August 23, 2013
Subject: **Puddle Dock Bridge**
State WIN: 20914.00
Location: Albion
Amendment No. 1

STATE OF MAINE DEPARTMENT OF TRANSPORTATION	ALBION KENNEBEC COUNTY	SHEET NUMBER 1
PUDDLE DOCK BRIDGE	NOTES	8/22/13 PK OF 2

Transverse Section

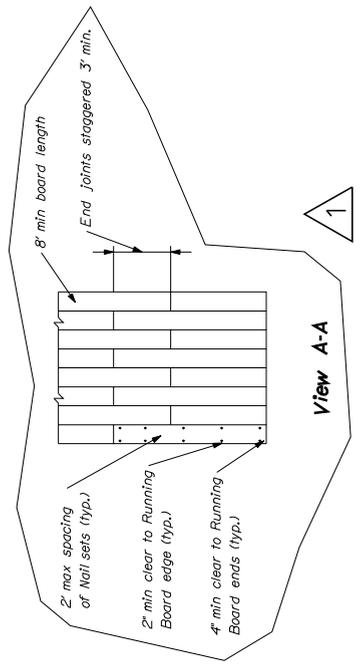
Question: Please confirm spacing on the 5/8" curb to deck bolts. Additionally there is a conflict between the hardware schedule and the transverse section re: bolt lengths. I assume the hardware schedule to be correct on this?

Response: There shall be one curb to deck bolt at every 1ft scupper block and one curb to deck bolt at every curb end (i.e. two bolts at 2ft scupper blocks). The Hardware Schedule is correct.
